**ZONING CHANGE REVIEW SHEET**

**CASE:** C14-2017-0084  
6507 Riverside Drive

**REQUEST (ERC PLAN AMENDMENT):**

**SUMMARY STAFF RECOMMENDATION:**

**FIGURE 1-2: East Riverside Corridor Subdistrict Map  
C14-2017-0084 - 6507 E. Riverside Drive**

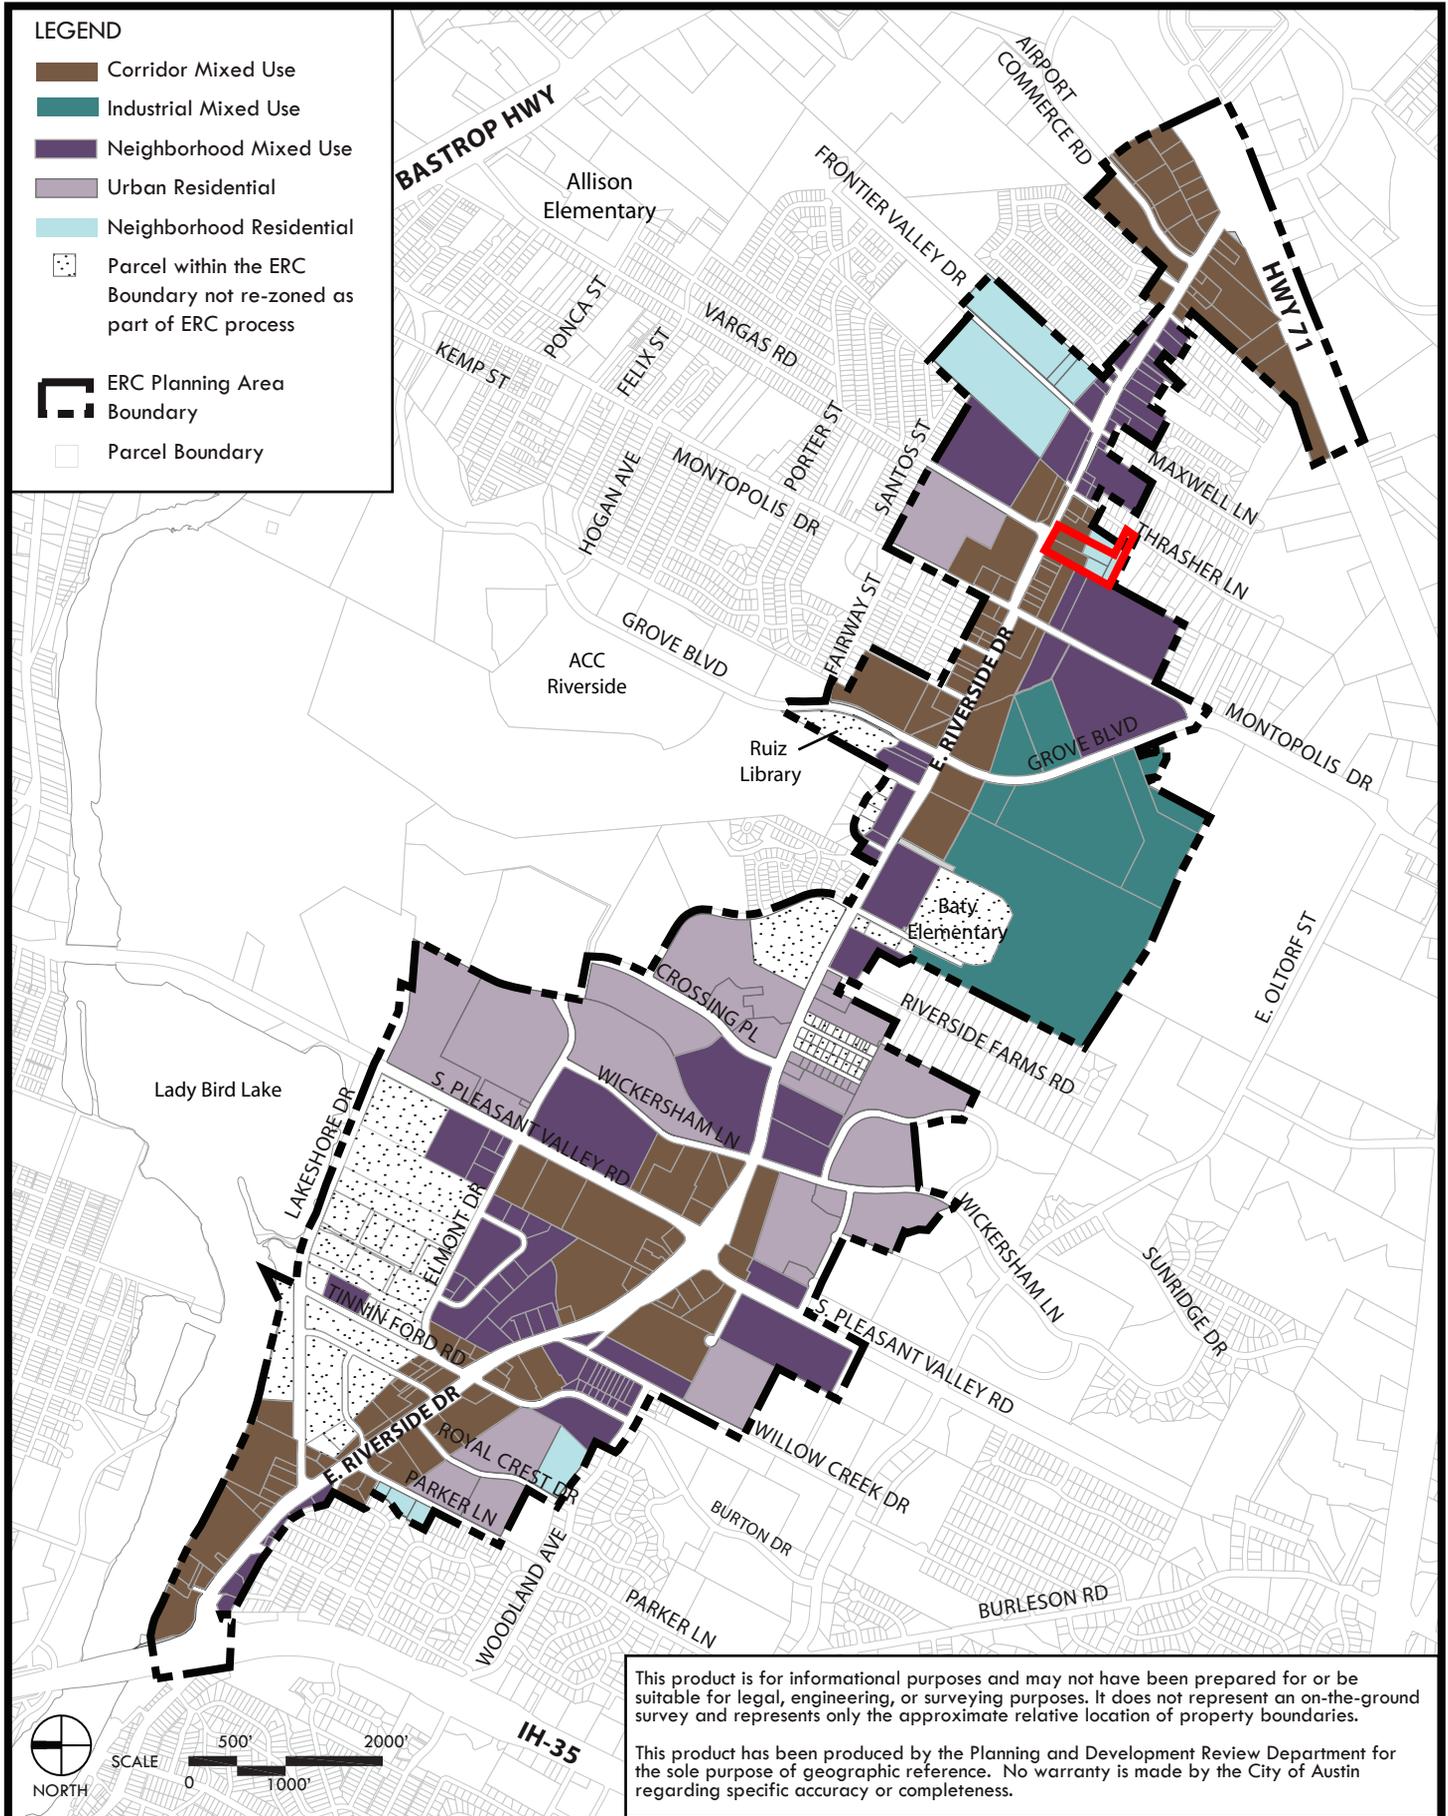
**Amendment # 1 / Amendment to the Subdistrict Designation (ERC Plan Figure 1-2)**

The subject tract is currently designated Neighborhood Residential (see Exhibit C – 1). Per the ERC Regulating Plan, Neighborhood Residential (NR) is a subdistrict between the higher density, more active urban subdistricts and residential sub-districts and districts. Staff can support the requested change if adjacent property (2110 Thrasher Lane) is zoned SF-6 (C14-2017-0126) to serve as a transition to the adjacent SF-3 to the south.

Staff recommends the subdistrict designation of Corridor Mixed Use (CMU) IF the property at 2110 Thrasher Lane is changed from SF-3 to SF-6 to serve the same function as the ERC-NR portion of this property. With the change to CMU the development will have unified development standards allowing a more cohesive project. A significant portion of the property is likely to be subject to compatibility standards which will impact the final height of the buildings.
